Beckfoot Phoenix School - Accessibility Action Plan.

Updated: 10/01/2025

Figure 4 — Access around designated off street parking spaces

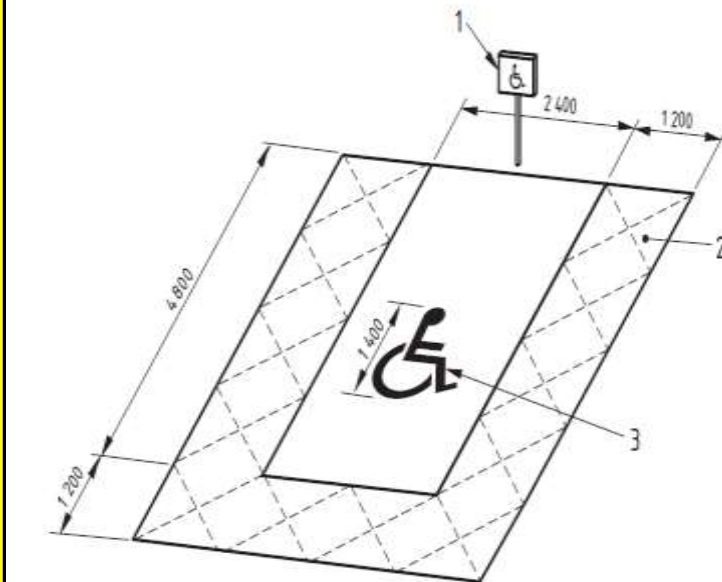
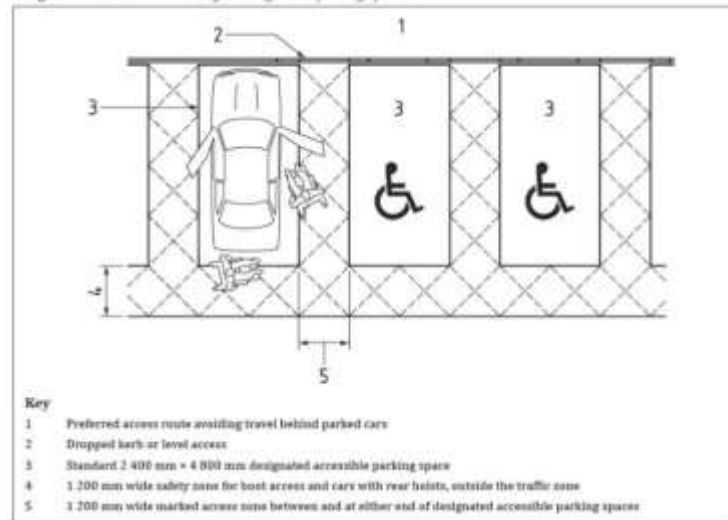
2.3	<p>The first 5 designated accessible parking should be clearly marked out at least 2.4m wide x 4.8m long plus a 1.2m side transfer zone at the side and end of the bay.</p>	<p>The accessible bay markings should provide clearly defined 1200mm transfer zones to both sides and rear and with the required access symbol.</p> <p>BS8300 recommends a sign or, if appropriate, signs should be provided at the entrance to each car park and at each change in direction to direct disabled motorists to designated parking spaces. Also, install a sign to the front of each space as shown:</p>	M

Figure 45 — Unisex accessible toilet with penicular WC for assisted use

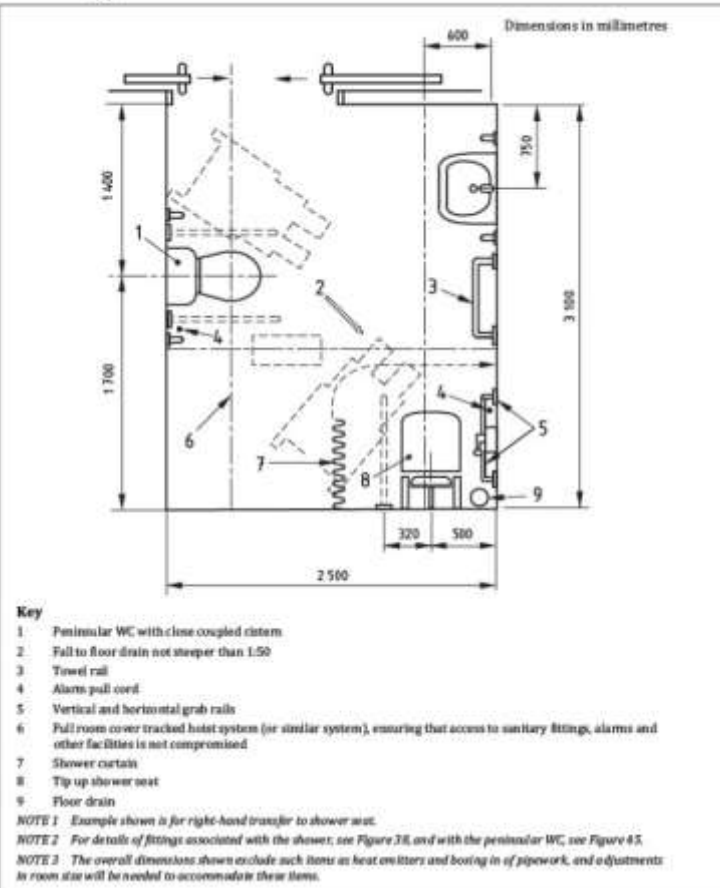
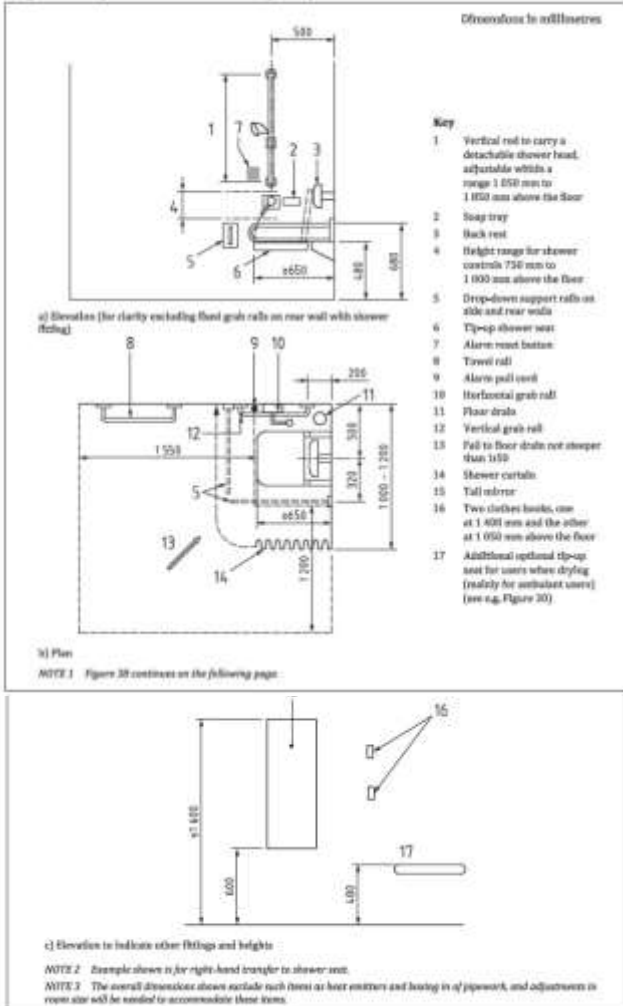
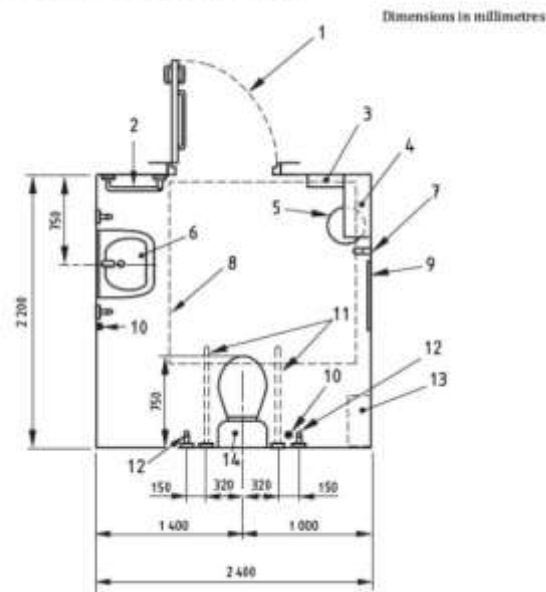
12.8	<p>Various accessible changing rooms were provided and with all having ceiling mounted hoists and some with changing beds. All had peninsular style WCs.</p> <p>Most had tip up shower seats with drop down rails to either side but none had vertical wall mounted rails. None of the sinks had wall mounted grab-rails.</p> <p>Two showers with stepped access and no grab rails were seen but as there is range of accessible facilities this would be deemed suitable to retain - but for future development consider showers with level access and grab-rails for the shower.</p> <p>Grab rails and WC seats contrasted but the sinks and WC pan did not contrast.</p> <p>A mixture of flushes were seen.</p> <p>All had lever taps for showers and sinks.</p> <p>Alarm cords for most were tied up or cut off.</p> <p>Changing areas for hydro pool - 38, 39 mirror of each other, cords tied up.</p> <p>Showers by hydro pool - 31, 32, same</p> <p>Shower and WC 56, 57, same</p> <p>Wet room/ shower 76 no sign on door cord cut</p> <p>Wet room/ shower with hoist 94 not used as shower.</p> <p>Wet room/ shower with hoist 122 (123 mirror image)</p> <p>Wet room/ shower & WC with hoist 132</p>	<p>Colour contrast should be added to the fixtures and fittings within the showers, or the walls should contrast from the fittings.</p> <p>According to BS8300 - to help blind and partially sighted people identify key objects within sanitary accommodation, support rails and grab rails should contrast visually with the wall, the WC seat and cover should contrast visually with the WC pan and cistern, and sanitary fittings and accessories should contrast visually with the background against which they are seen.</p> <p>Refer to BS8300 recommendations regarding the locations of grab rails and other fittings, as appropriate, for peninsular style WC and bathroom facilities.</p> <p>Refer to recommendation for 13.11 regarding cord alarms.</p>	M/OG

Figure 47 — Urinals accessible to wheelchair users and people with ambulant mobility impairments

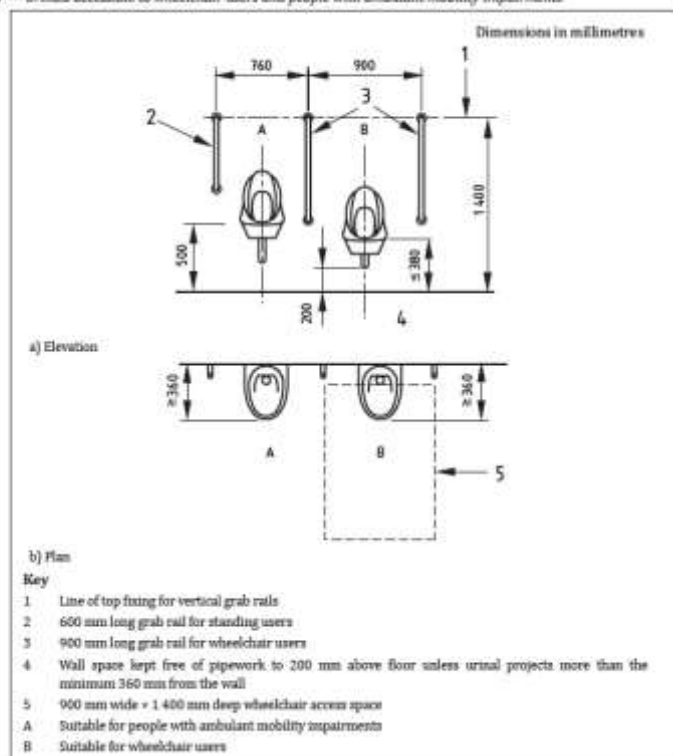
12.5	Urinals in the boys WCs contrast but do not feature grab rails to aid ambulant disabled persons.	<p>It is suggested that urinals for wheelchair users and ambulant disabled people are provided as well. The wheelchair space in front of a urinal should be level. Vertical grab rails for the benefit of a disabled person who is standing should be provided on each side of a urinal where stall privacy dividers are not fitted.</p> <p>Fittings, support rails and grab rails should contrast visually with the wall; the WC seat and cover should contrast visually with the WC pan and cistern; and sanitary fittings and accessories should contrast visually with the background against which they are seen.</p> <p>See below for suggested layout.</p>	M	
------	--	---	---	--

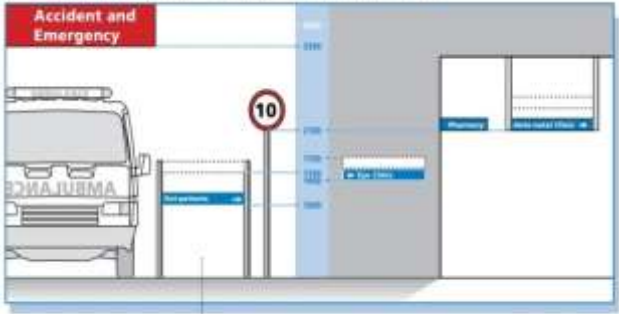
<p>15.2</p>	<p>Upon entering the reception area there is a lack of suitable directory signage.</p> <p><small>This diagram gives general guidance on the suggested height for positioning different types of sign, determined by the intended use of the sign (all dimensions are given in millimetres)</small></p>  <p><small>NOTE: Position external signs that are likely to be obscured by passing or parked vehicles at least 1500 mm from the ground. Signs that are located away from possible obstructions can be positioned lower.</small></p>	<p>Signs and universally accepted symbols or pictograms, indicating lifting appliances, stairs, toilets, circulation routes and other parts of the building, should be provided in the reception area. The NHS Wayfinding guide and Exhibitions for All (NMS) offers good guidance regarding positioning.</p> <p>Consistency of sign height and position throughout the premises is important. Signs should be placed between 1400mm and 1700mm for blind and partially sighted people when standing. For wheelchair users signs should be placed between 1000mm and 1100mm above floor level. Signs associated with control panels, e.g. lifts or door entry systems should be located between 900mm x 1200mm, to meet the needs of both wheelchair users and people standing.</p> <p>The RNIB and the Joint Mobility Unit recommend positioning all signs at eye level (1500 mm), including tactile (embossed) and Braille signs. If posts are used for fixing signs, or signs are free-standing, they must contrast with the environment so they are visible for people with visual impairment.</p>	<p>M/OG</p>

Figure 50 — Work surfaces and accessories

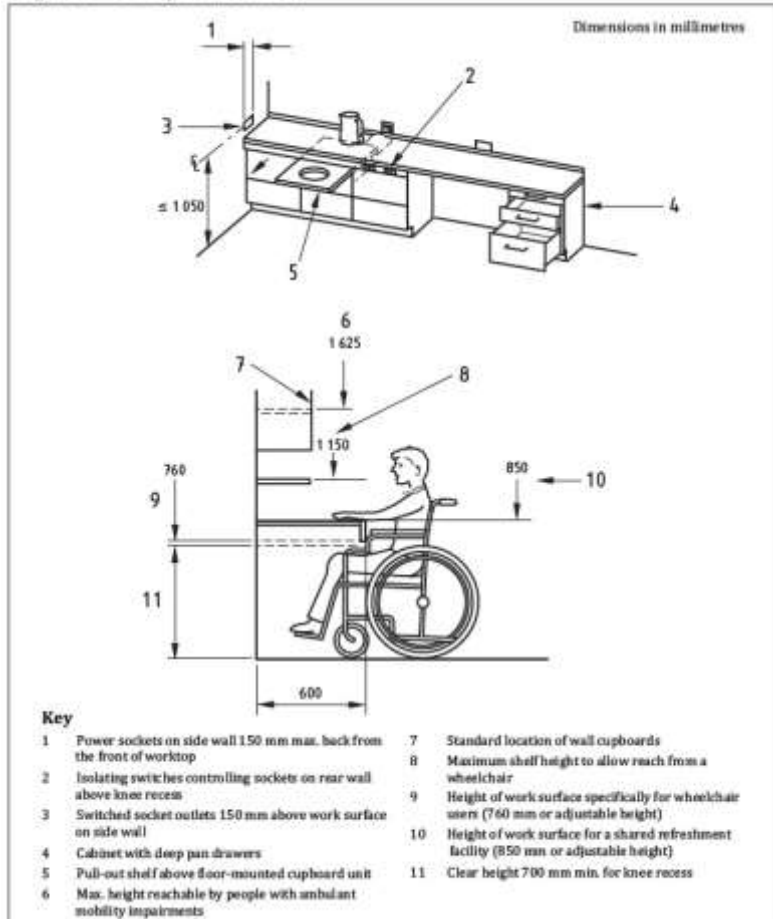
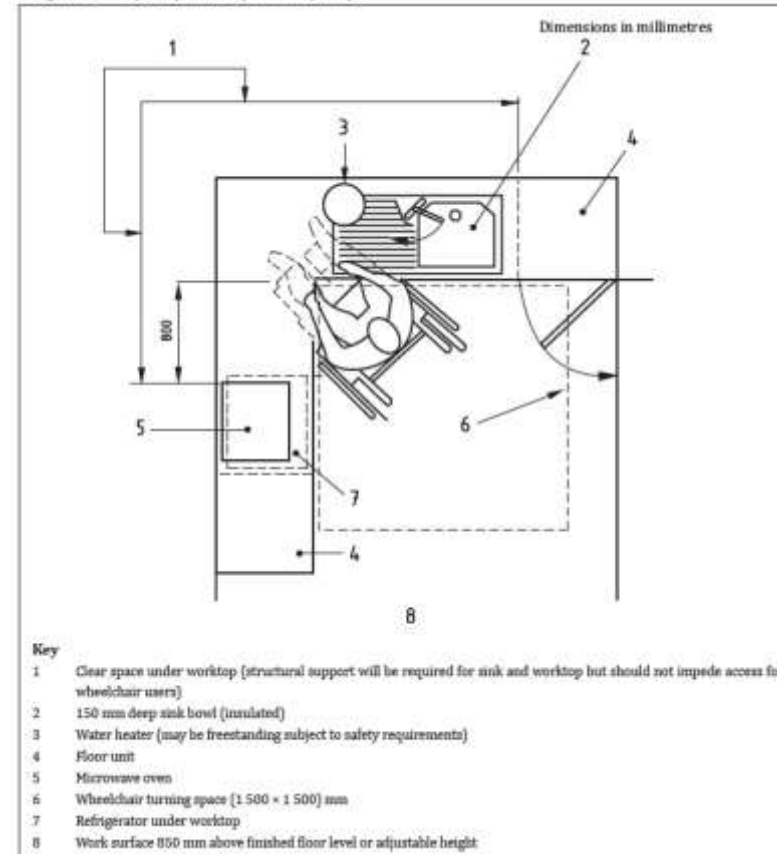
14.8	<p>A range of taps were seen and some were lever style taps. Others were turn taps.</p> <p>Classrooms had sinks with taps but not lowered counters.</p> <p>Room 86 teaching kitchen, 131 nursery kitchen have height adjustable hobs.</p> <p>Nursery has height adjustable sink in main area.</p> <p>Parents meeting room had a lower counter but not a specific style intended for use by a wheelchair user.</p>	<p>A kitchen area should have an unobstructed floor space of at least 1 500 mm × 1 500 mm between facing floor units or between floor units and a wall. Where possible, an unobstructed space or knee recess, at least 800 mm wide, should be provided to one side of kitchen appliances such as refrigerators, washing machines, freezers or ovens.</p> <p>Taps should be changed to lever style or automatic sensor taps to aid people with limited dexterity.</p> <p>The kitchenettes should include disability access, i.e., a section of work top lowered to 760mm (or 850 for a shared worksurface) with clear space underneath of minimum 700mm to allow wheelchair access; sink unit to have lever taps fitted, and utensils included.</p> <p>Refer to images.</p>	M/ST
